MEMO

DATE: March 26, 2014

Response to Star-Orion South Diamond Project – Federal Environmental Assessment Federal Information Request (December 18, 2013)

This Memo provides responses to Round 4 Federal Comments received by Shore Gold Inc (Shore) from the Canadian Environmental Assessment Agency on December 18, 2013.

Figure 1. Potential Changes to Stream Flow

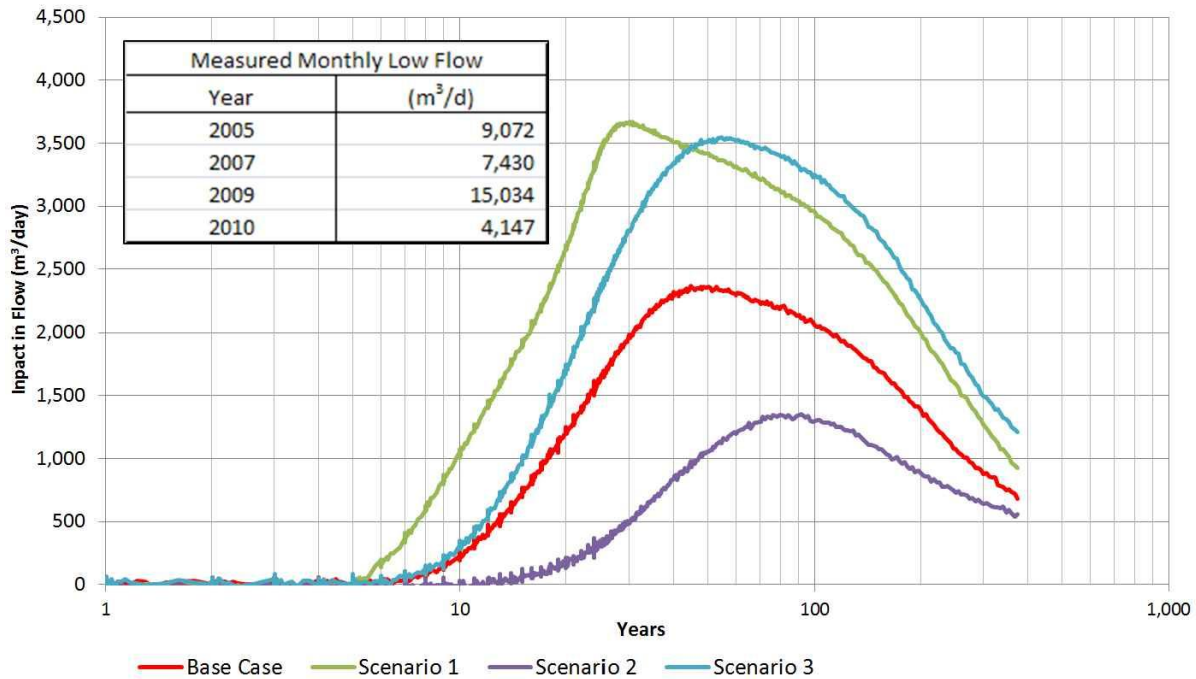
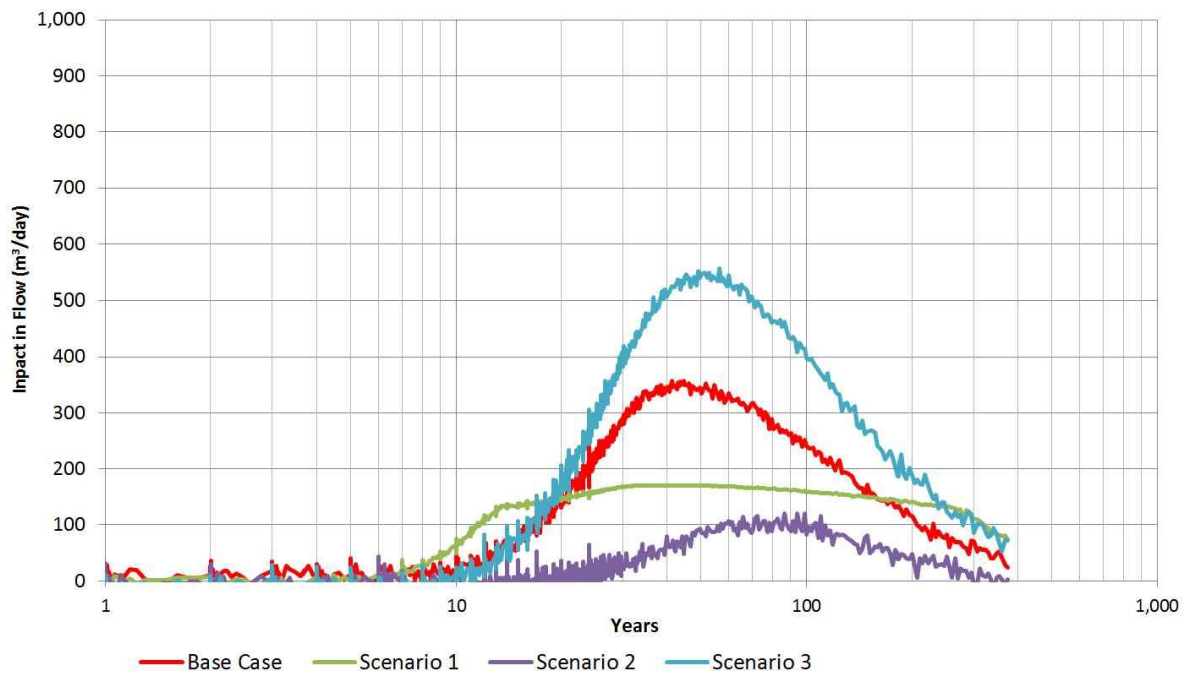
Potential changes in effects to fish habitat result from the same modeling uncertainties as described above in the section discussing potable water wells. NRCan identified a risk that surficial drawdown in the sand, clay, and upper till units may further reduce groundwater contribution to base flow in nearby creeks

and ravines. Figure 43 (Appendix 5.2.7-A in the REIS) shows a range of potential impacts to flow in local streams based on scenarios increasing the hydraulic conductivity of the aquitard units by a factor of 3. Comparing scenario 1 in Figure 43 to the baseline, impact may be larger than baseline in creeks and ravines near to the Project (Figure 1(a) below), and less or equivalent to impacts predicted on creeks and ravines south of the Saskatchewan River (Figure 1(b) below).

From Table 17 (Appendix 5.2.7-A of the REIS), the base case model predicts a decrease in 2,410 m³/day of groundwater discharging to the Saskatchewan River. In Scenario 1, this number increases to 5,080 m³/day. Without consideration of pit dewatering inputs, the maximum reductions in flow from Scenario 1 is 0.046% of the 10 year return period, seven day low flow (128 m³/s). Considering that the Project is expected to increase flow in the Saskatchewan River through management of between 80,000 m³/day and 120,000 m³/day, the maximum possible reduction in input is offset by increases due to mining.

Shore Gold has committed to monitor and supplement flows in local creeks and ravines (English Creek, 101 Ravine, and Duke Ravine) to maintain or exceed 115% of base flow in order to avoid impacts to fish and fish habitat. This mitigation will be extended to any other potentially affected watercourses providing fish habitat so that impacts are avoided. Make-up water would continue to be sourced from the East Ravine diversion or the Saskatchewan River intake. This avoidance of additional potential effects will not change the proposed Fish Habitat Compensation Plan. Monitoring and mitigation by low flow supplementation would begin at construction and continue post closure for at least 20 years, until the site is returned to an appropriate state, or until the site can be returned to provincial control.

Date:	Analyst:	Figure 7.4-3
October, 2013	BD	
Projection:	QA/QC:	Datum:
UTM Zone 13	ER	NAD27

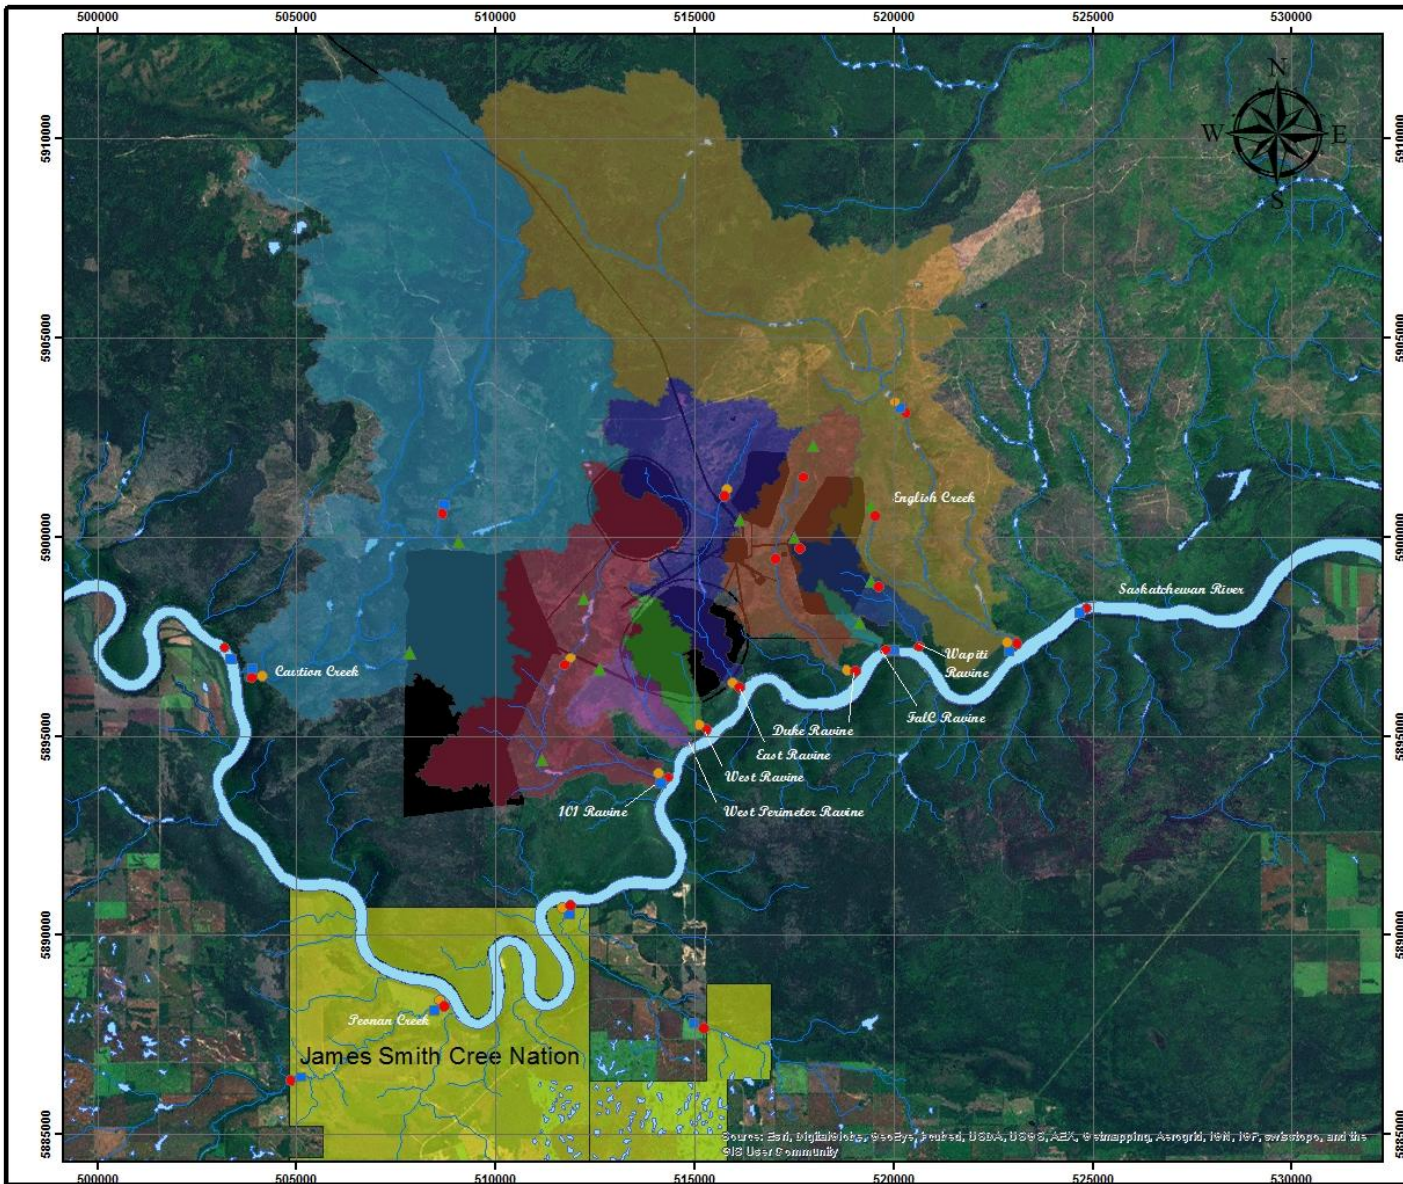
Confirm whether an Aquatics Effects Monitoring Program will be in place for the Star-Orion South Diamond Program, when it will be created and implemented, and the proposed content.

Sample locations were selected in the REIS based on a reference-exposure sampling method. Locations are marked on Figure 7.4-3 (Revised October 2013; attached) with reference locations upstream of the Project on the Saskatchewan River, at Pehonan Creek and Stream F. Additional reference sites are planned up gradient of the Project on English Creek and Caution Creek. Predicted exposure sites include the mouth of the 101, East, Duke and Wapiti Ravines, and the mouth of English and Caution Creek. Two exposure locations are planned in the Saskatchewan River: one immediately downstream of the Project discharge, and one down River, past English Creek. These locations will be confirmed during detailed study design.
